2020 Corvette: Front Fender and Fascia Realignment

June 16, 2020
GM TechLink

Fig. 11

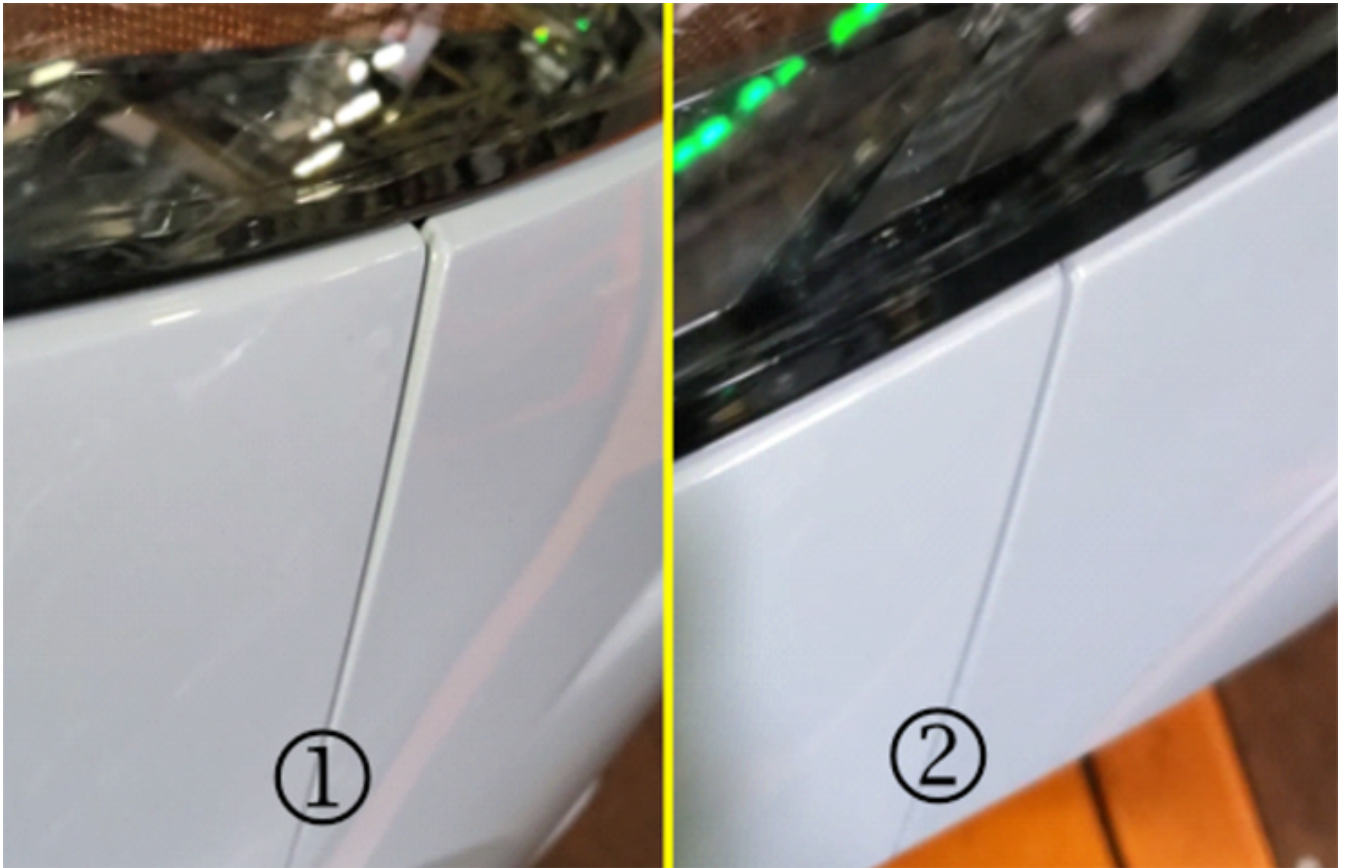
Some 2020 Corvettes may have a small paint chip in the front fascia below the headlamp on one or both sides of the vehicle. (Fig. 10) The paint chip may be caused by a mis-positioned fender-to-fascia gap joint.

The fender and fascia joint fit should be realigned. (Fig. 11, #1) The realignment will reposition the fender and fascia downward and inboard so that the fascia is flush with the fender. After realignment, the paint chip will no longer be visible. (Fig. 11, #2)

Follow the realignment procedure in Bulletin #20-NA-124. The front tire and wheel assembly, front wheelhouse liner and front wheel opening molding must be removed on the affected side of the vehicle.

Fig. 12

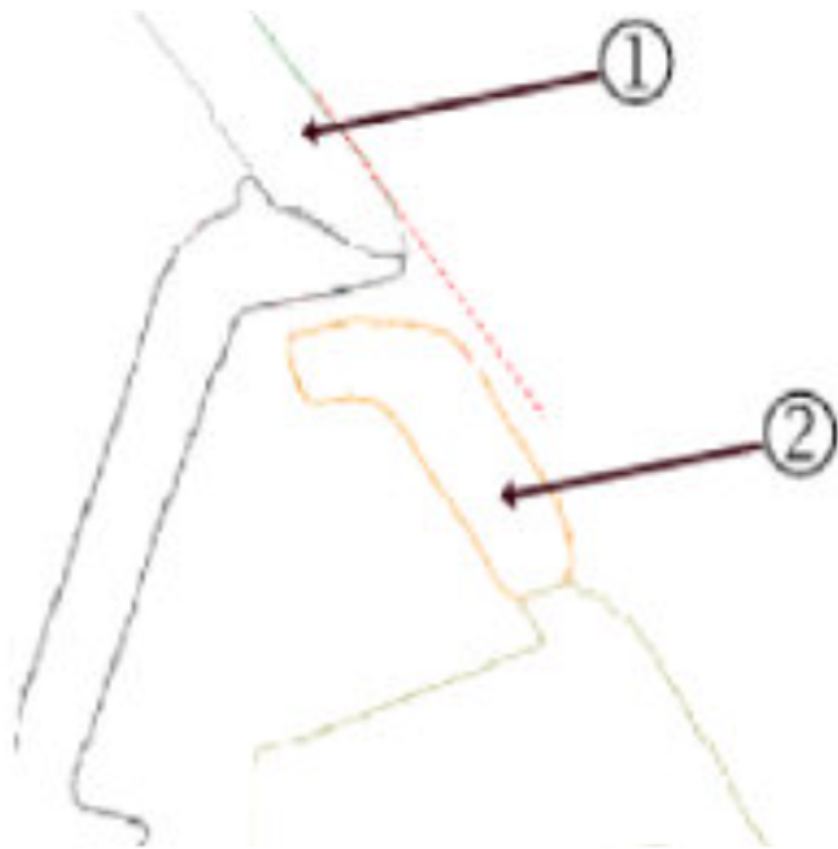
After adjusting the fender inboard, the headlamp lens (Fig. 12, #1) will be proud of the fender (Fig. 12, #2) and the fascia tip will install below the headlamp lens. (Fig. 13)
